SUBJECT: Forwards util response to NUREG-0619, "BWR Feedwater Nozzle & Control Rod Drive Return Line Nozzle Cracking."
 Response should close out open item in facility draft SER.

Subject: NUCLEAR PROJECT NO. 2
WNP-2 RESPONSE TO NUREG-0619

WNP-2 RESPONSE TO NUREG 0619
"BWR FEEDWATER NOZZLE AND CONTROL
ROD DRIVE RETURN LINE NOZZLE CRACKING"

SUPPLY SYSTEM RESPONSE
TO FSAR QUESTION 121.008

- ① Nozzle, SA-508, C.I. II
- ② Safe End, SB-166, Inconel
- ③ Thermal Sleeve Extension, SB-166
- ④ Thermal Sleeve, SA-336, C.I. F8
- ⑤ Inconel Overlay
- ⑥ Weld Illustration
- ⑦ Back-up Ring, SB-168

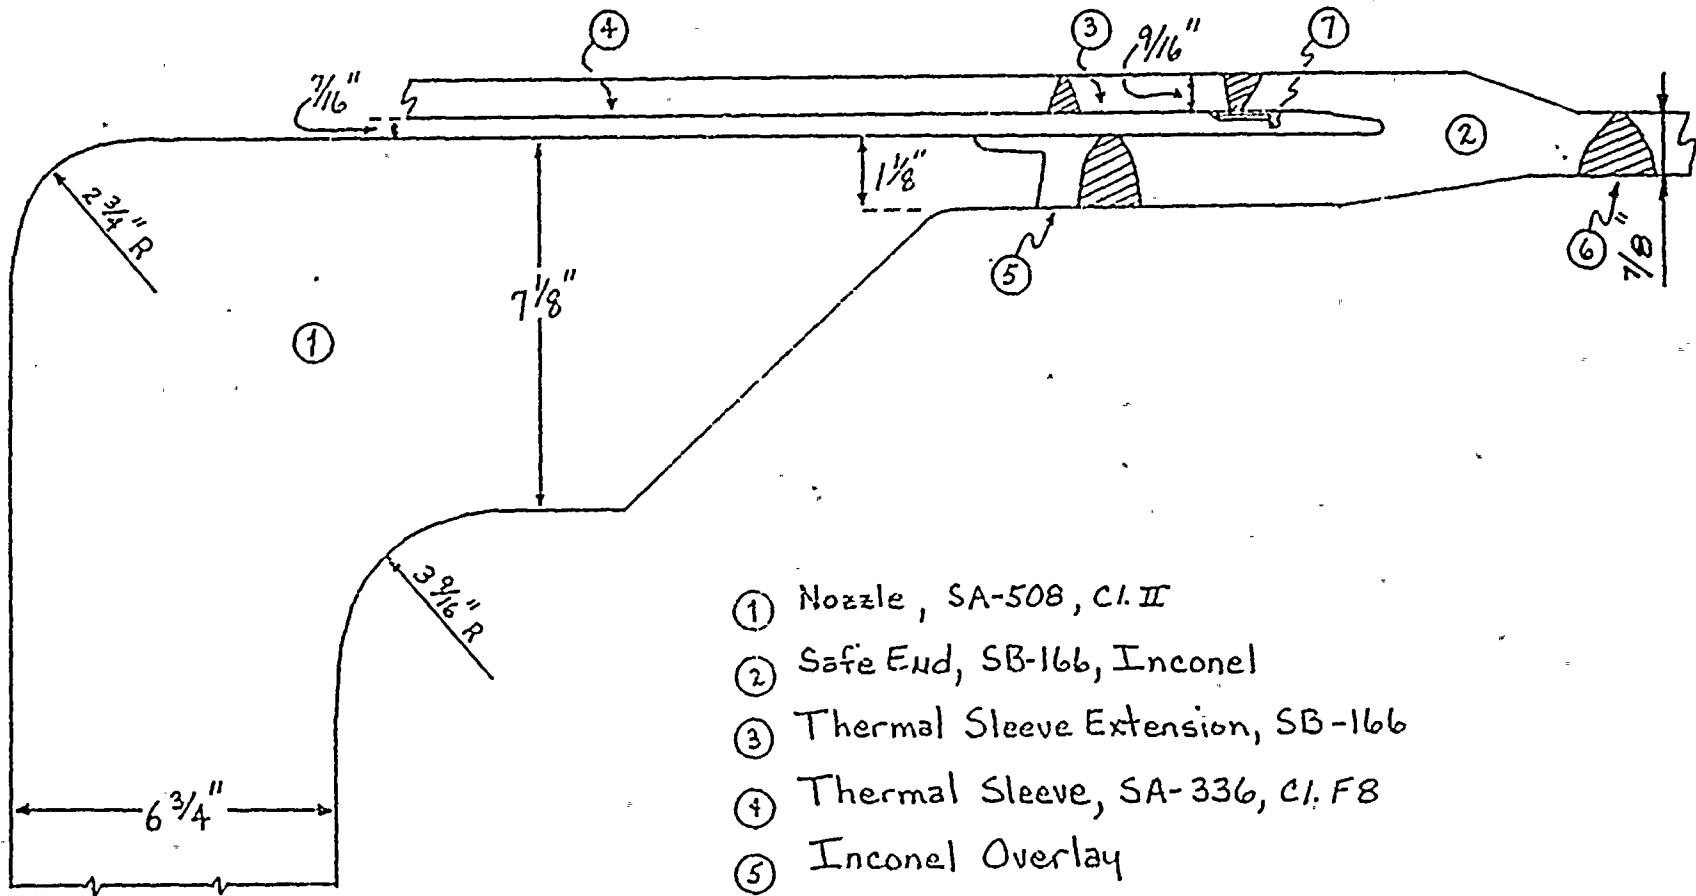
(In response to this item, refer to the responses to Items 121.15 and 121.18 on the Hatch-2 docket.) Additional information is required to demonstrate that: (1) the thermal sleeve/sparger design of the feedwater inlet nozzle has been evaluated with respect to potential nozzle cracking resulting from thermal cycling; and (2) a program of scheduled augmented inservice inspection has been developed.

Your response should contain: (1) a description of the nozzle and sparger design including the significant dimensions, the materials of construction and the weld locations; (2) a description of the analyses and test data, referencing appropriate data previously submitted to the NRC staff if it is applicable for the WNP-2 facility; (3) the detailed projected crack growth rates, stress levels and usage factors for both the nozzle and the sparger; (4) any plant modifications that are planned to reduce the temperature differential between the feedwater and the water in the reactor pressure vessel during low power operation; and (5) a description of any instrumentation that will be installed in the reactor pressure vessel to verify the conclusions of your design analysis.

A description of the WNP-2 feedwater nozzle and sparger is presented on Figures 121.8-1 and 121.8-2.

The sparger vibration has been attributed to a self-excitation caused by instability of leakage flow through the annular clearance between the thermal sleeve and safe end. Tests have shown that the vibration is eliminated if the clearance is reduced sufficiently or sealed. The solution which has been selected for WNP-2 uses a welded joint to assure no leakage. This feature is also an essential part of the solution of the nozzle cracking problem. Freedom from vibration over a range of conditions has been demonstrated by the tests reported in NEDE-23604.
